PRODUCT CHANGE NOTIFICATION (PCN)

AMJE0909-0100-RDB-24
MODULAR CABLE

CHANGE NOTIFICATION: PCN 20220509_AMJE0909-0100-RDB-24

DESCRIPTION OF CHANGES:
CHANGE OF DATA SHEET
CHANGE OF DATA SHEET
New Draw.-No. ASS_7945_CArev02

AMJE0909-0100-RDB-24 OLD VERSION

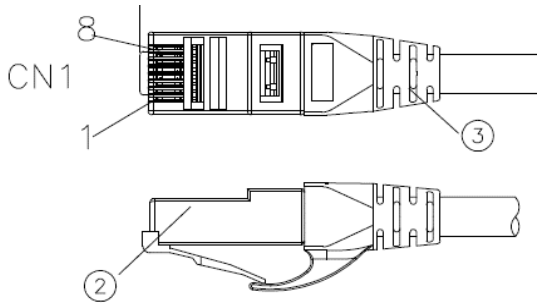
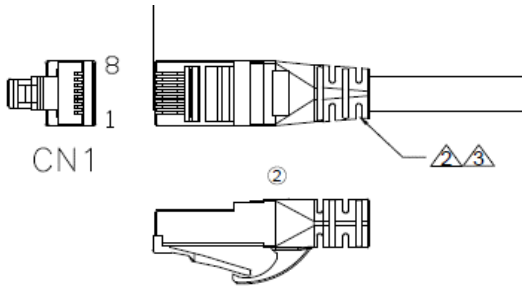
③	Molding	PVC 45P Color: see order code	NA	KG
②	CONNECTOR	RJ45 8P8C two fork Short type 3u" gold plated	2	PCS
①	CABLE	CAT6 UTP (24AWG*1PR)*4+PVC OD=5.8±0.3MM Color: see order code	NA	MM
NO:	NAME	DESCRIPTION	Q'TY	UNIT

3	Molding	PVC 65P Color: see order code ②	NA	KG
2	CONNECTOR	RJ45 8P8C PLUG 3u" gold plated ②	2	PCS
1	CABLE	CAT6 U/UTP (24AWG*1PR)*4+Cross+PVC Jacket OD=5.8± 0.3MM Color: see order code ②	NA	MM
NO:	NAME	DESCRIPTION	Q'TY	UNIT

Drawing-No.
ASS 7945 CA

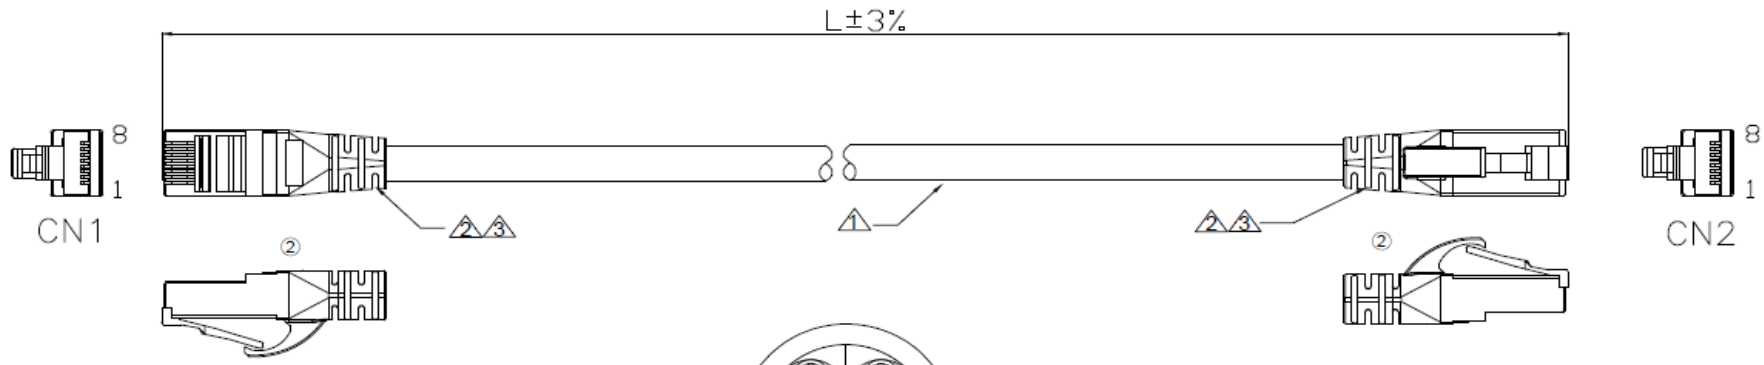
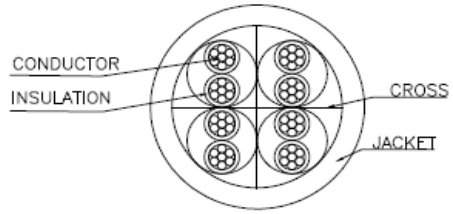
Id.	Modification	Date	Name
②	Change the plant	09.05.2022	Luca
①	Update the WSW order code	02.06.2017	Amy
⓪	Drawn	30.03.2017	Amy

NO:	NAME	DESCRIPTION	Q'TY	UNIT
3	Molding	PVC 65P Color: see order code ②	NA	KG
2	CONNECTOR	RJ45 8P8C PLUG 3u" gold plated ②	2	PCS
1	CABLE	CAT6 U/UTP (24AWG*1PR)*4+Cross+PVC Jacket OD=5.8± 0.3MM Color: see order code ②	NA	MM
